9. COA-087770-2021

908 North 24th Street

Commission of Architectural Review

STAFF REPORT

Figure 1. Sanborn map, 1925.

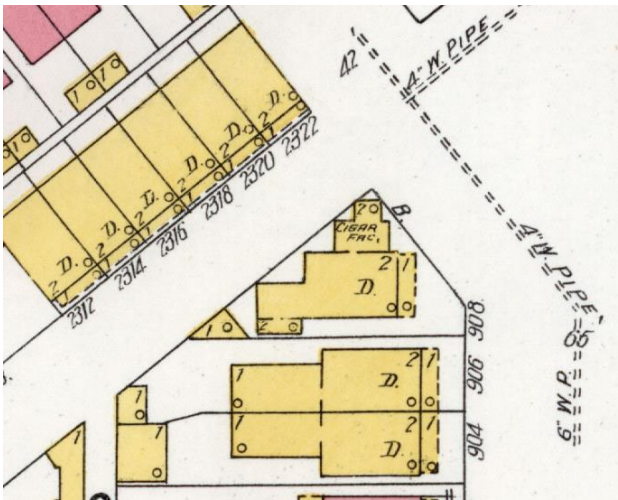
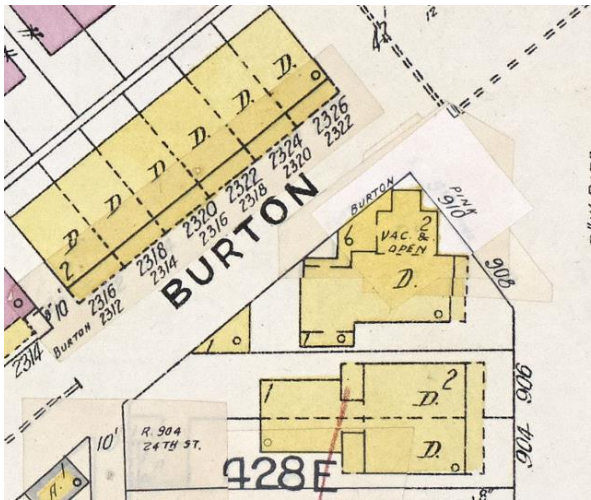
Staff notes that this is a corner property with views of the right side and rear elevation. Based on the Sanborn maps it appears the historic residence on this site had a bay window and engaged porch. Staff recommends the applicant consider incorporating either of these elements, or another design element, to address the corner guidelines.
